RESPONSE TO QUESTIONS 6, 8, 9, 15
17, 18, and 19

October 1989

Pacific Gas and Electric Company

Diablo Canyon Power Plant
Long Term Seismic Program

Figure Q6-1

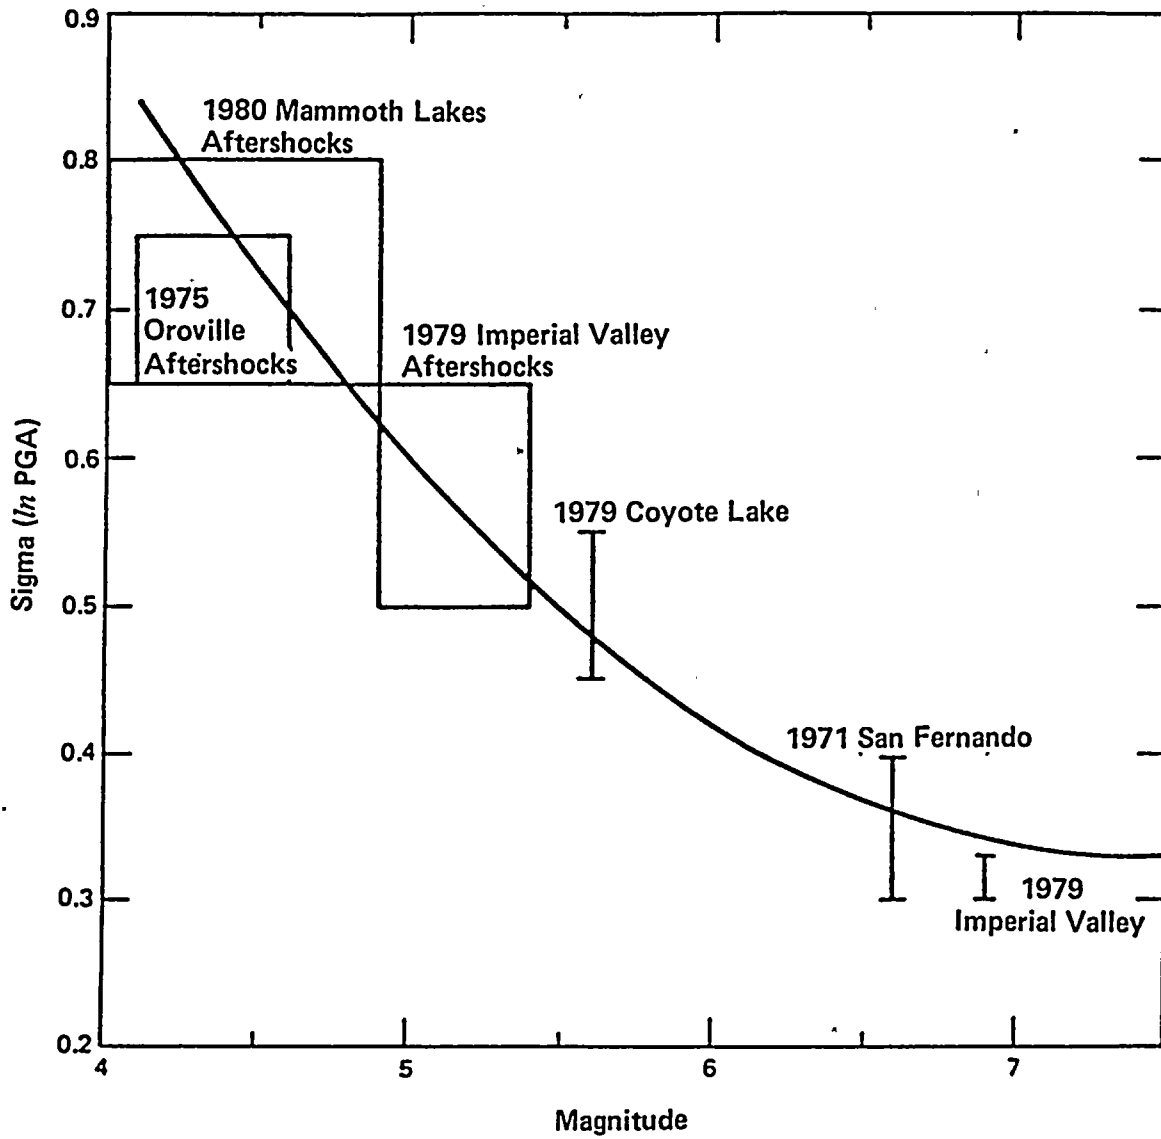
Is the apparent magnitude dependence of the dispersion in the empirical ground-motion analysis real or is it an artifact of the data set? For lower magnitudes the uncertainty may be due to inter-event dispersion while at larger magnitudes it may be due to intra-event dispersion.

Figure Q6-1 presents a typical result from the cited studies. The magnitude dependence in dispersion was evaluated by computing the standard error in the natural logarithm of a peak ground-motion parameter for data from narrow magnitude bands. The ground-motion data base used in those studies consisted primarily of recordings from two earthquakes: San Fernando, 1971 (6.6 M_w), and Imperial Valley, 1979 (6.5 M_w), and recordings from a large number of magnitude 4 to 6 aftershocks from three earthquakes sequences, Oroville, 1975, Imperial Valley, 1979, and Mammoth Lakes, 1980.

Figure Q9-1

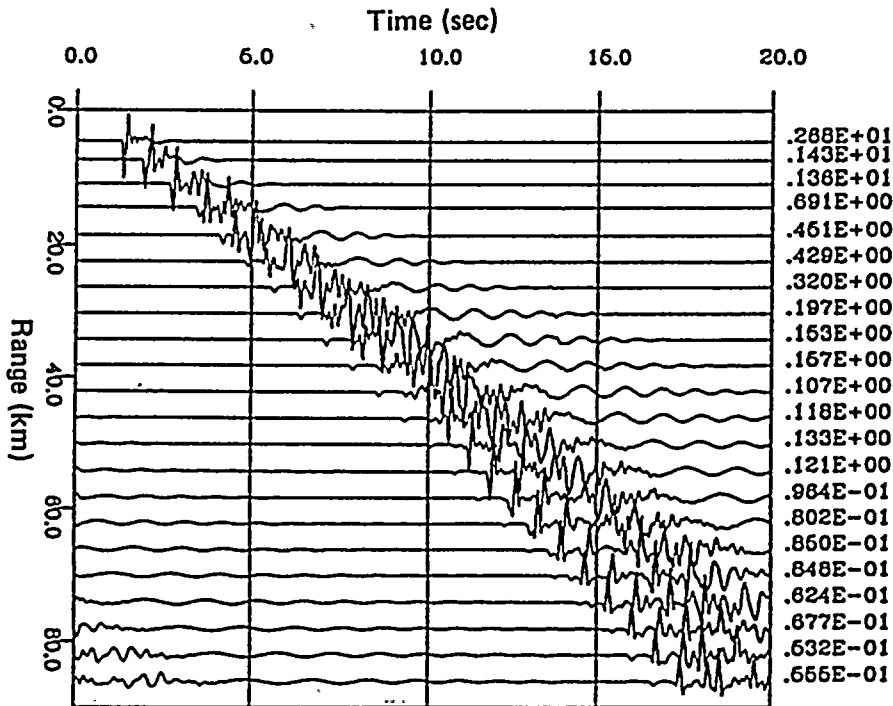
Provide a comparison between the numerical modeling study and the frequency-wave number method of the 1.5 km and 3 km source depth contributions.

Green's functions calculated for the tangential component arrivals using the generalized ray and wavenumber integration methods for source depths of 1.5 and 4.5 km are shown on Figures Q9-1 and Q9-2. Overall, there is good correspondence between the large, high-frequency phases that represent the principal direct and reflected rays. These phases were identified in strong-motion recordings at the site. The lower-frequency waves that follow the shear wave arrivals in the frequency-wavenumber Green's functions are surface multiples; these waves are not included in the generalized ray Green's functions. For the 1.5-km source depth, these surface multiples have amplitudes approximately twice those of the diving direct wave in the distance range of 20 to 40 km; at a distance of 22.4 km, they arrive at 7 and 6 seconds, respectively. Their amplitudes are relatively large only for the 1.5-km source depth, and as we shall see in the following comparison, they do not contribute significantly in the ground-motion simulations.

Figure Q15-1

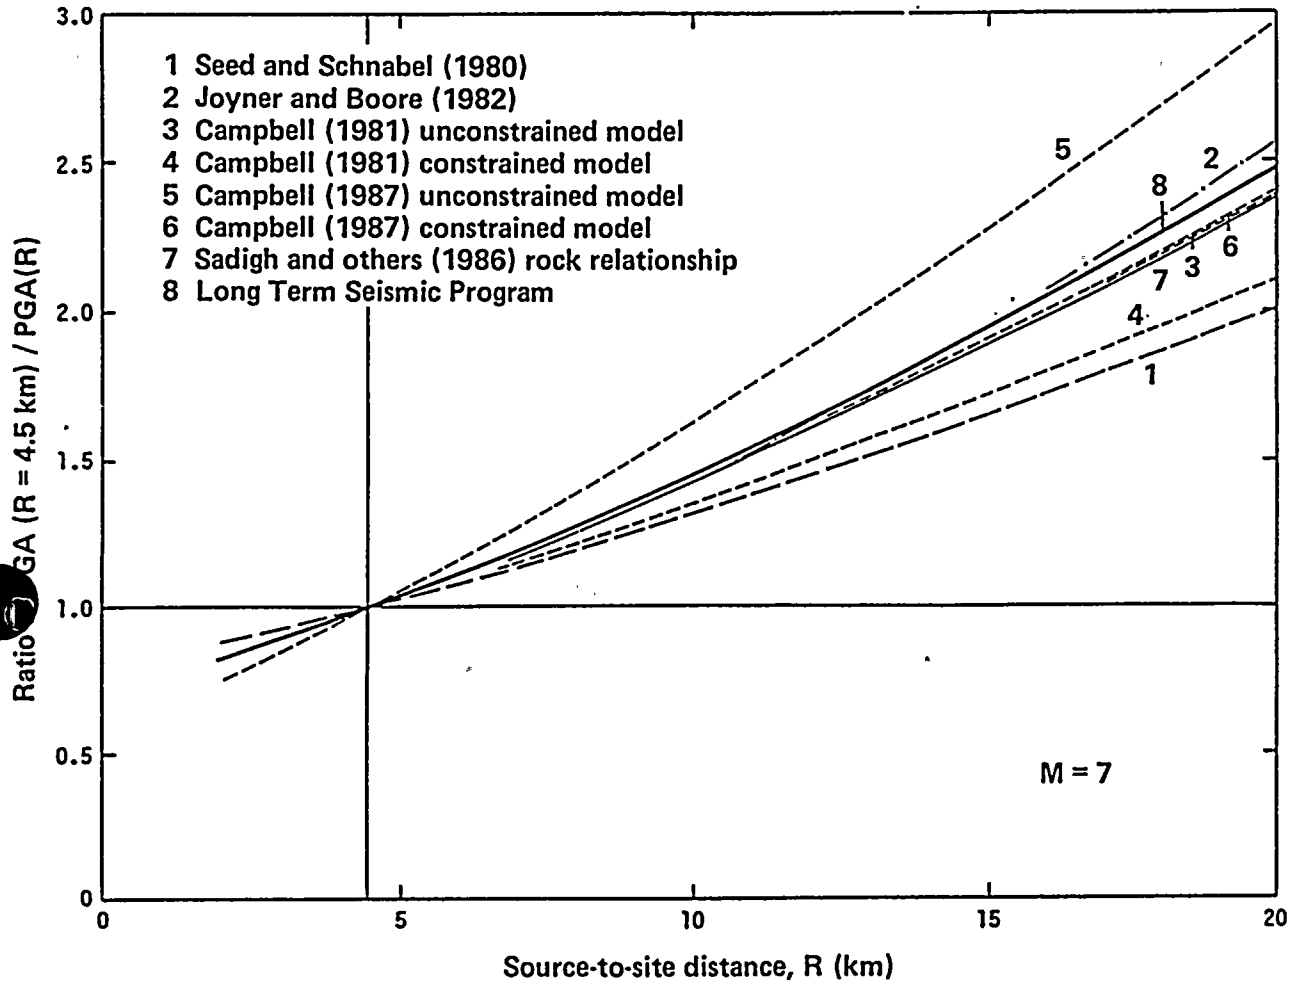
The derivation of the various adjustment factors used to modify the empirical ground motion and their individual effects have not been described in sufficient detail to permit an evaluation of their appropriateness. Please provide this information.

The various empirical relationships are summarized and compared in Figure Q15-1, (Figure Q9-1, January 1989) for a magnitude 7 earthquake at the distance range of interest to this study, between 2 and 20 km. The attenuation relationship selected for scaling the near-source recordings is shown by the solid line in Figure Q15-1 (based on the results of the regression analyses). Similar relationships were used for scaling for other magnitudes. The scaling relationships for magnitudes 6.5, 7.0, 7.2, and 7.5 in the distance range of 2 to 20 km are presented in Figure Q15-2 (Figure
